STATE OF WASHINGTON
DEPARTMENT OF ECOLOGY

Re: Opinion pursuant to WAC 173-340-515(5) on the "Revised Work Plan for Additional Soil and Air Quality Characterization" for the following Hazardous Waste Site:

- Name: Crownhill Elementary School
- Address: 1500 Rocky Point Road NW, Bremerton
- Facility/Site No.: 99722456
- VCP No.: NW2147

1. Revised Work Plan for Additional Soil and Air Quality Characterization Crownhill Elementary School, dated July 13th 2009, prepared by Terracon

PROPOSED SAMPLING LOCATIONS

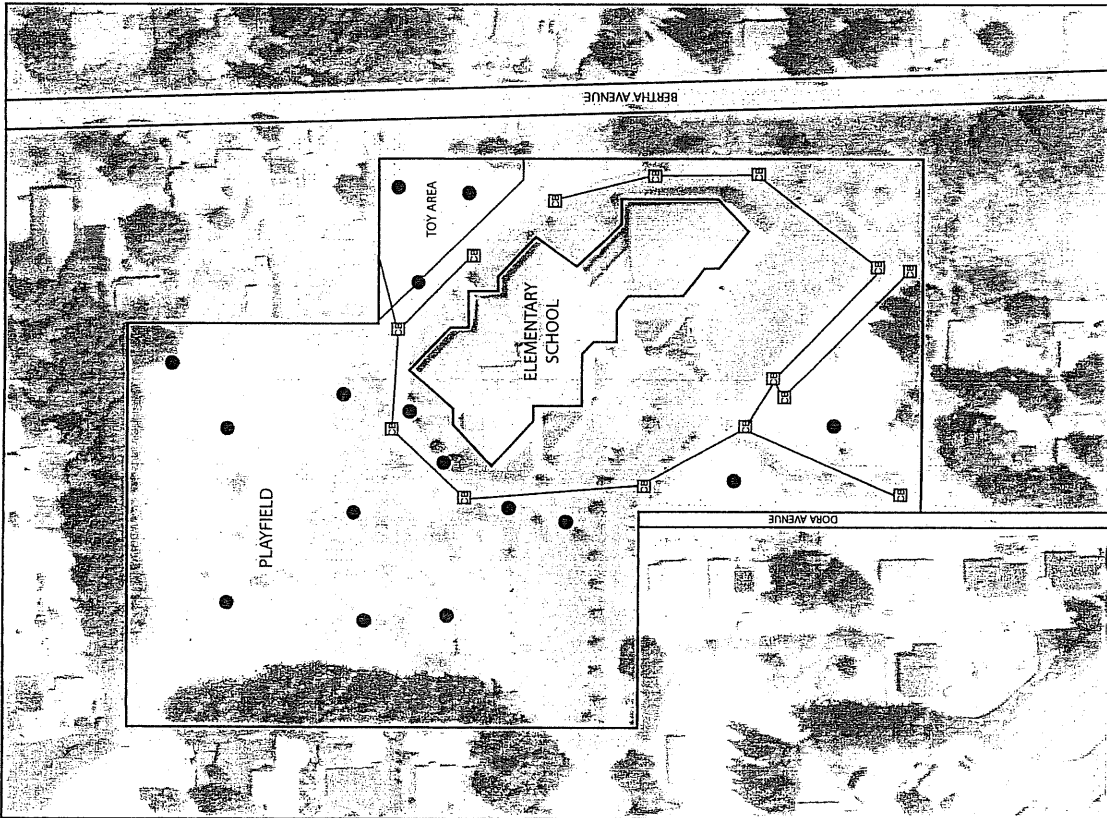
- The sixteen proposed soil sampling locations as depicted in Figure 5 of the "Revised Work Plan for Additional Soil and Air Quality Characterization", appear to be appropriately located;

- The three proposed air sampling locations as depicted in Figure 5 of the "Revised Work Plan for Additional Soil and Air Quality Characterization", appear to be appropriately located;

Historic Site Activity Map - 1946

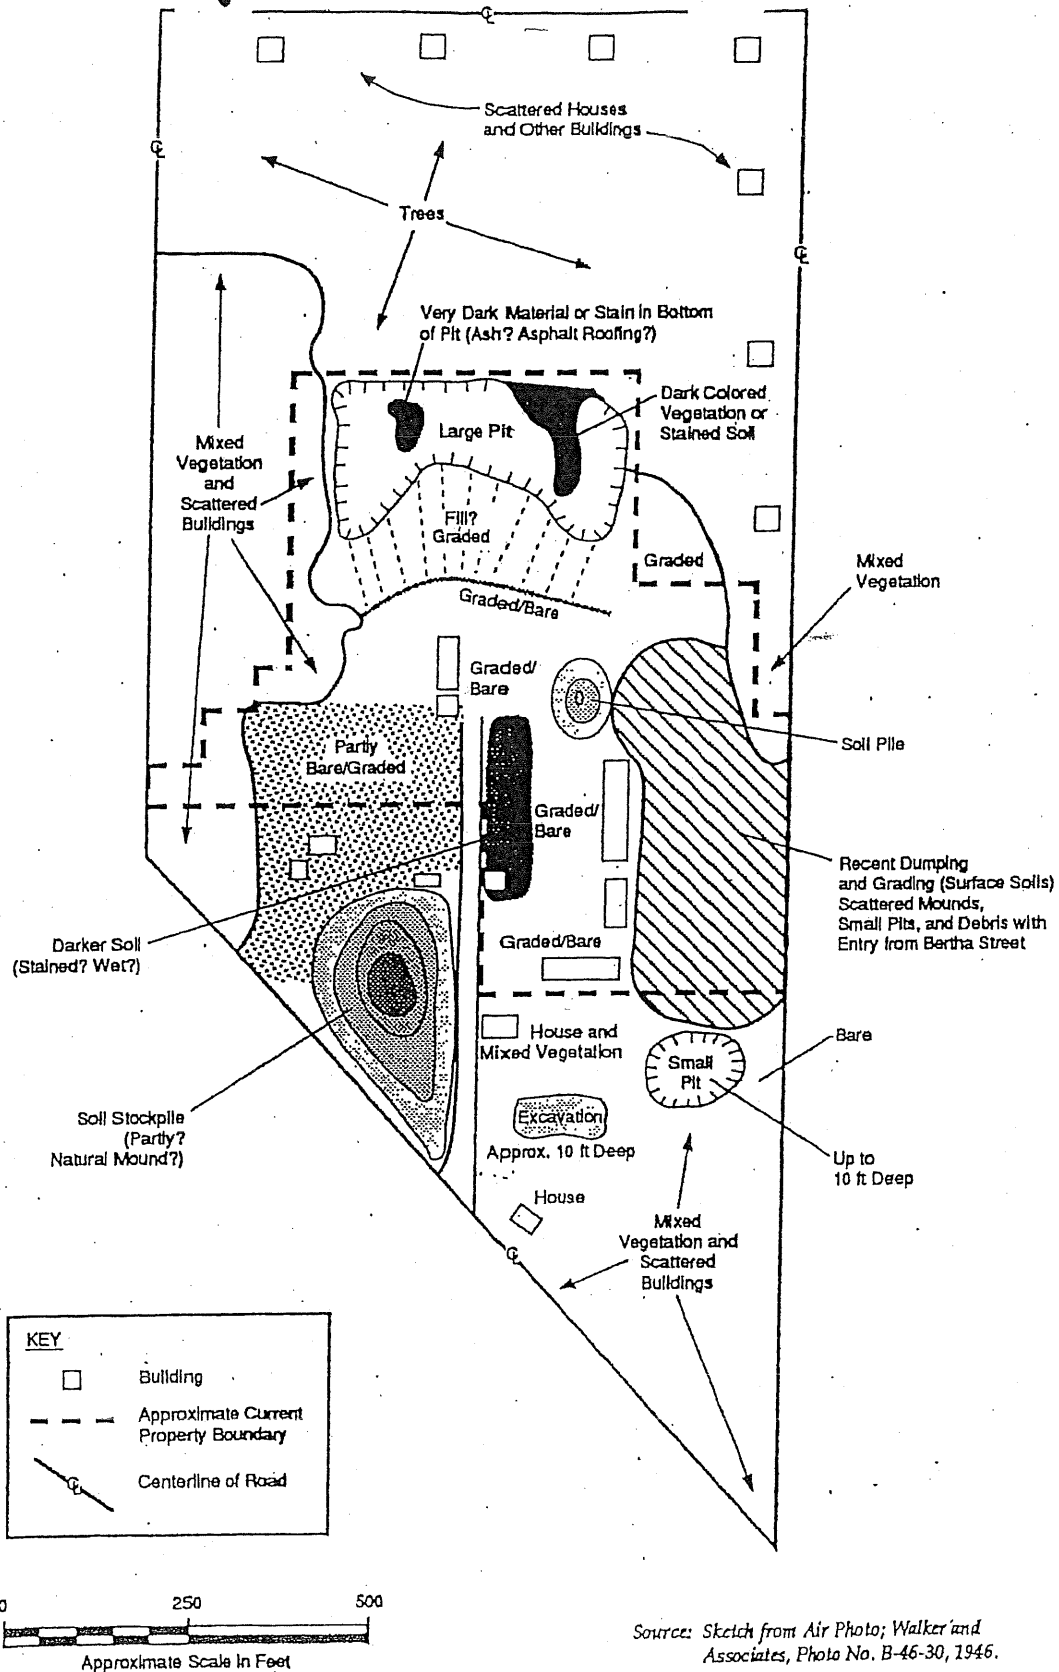
- The Historic Activity Map – 1946, which was included in the "Revised Work Plan for Additional Soil and Air Quality Characterization", shows the Site may extend to the west beyond Dora Avenue and to the east of the school property. Soil sampling to the west of Dora Avenue and to the east of school property will be required in order to determine if the Site extends beyond the Crownhill Elementary School property boundary;
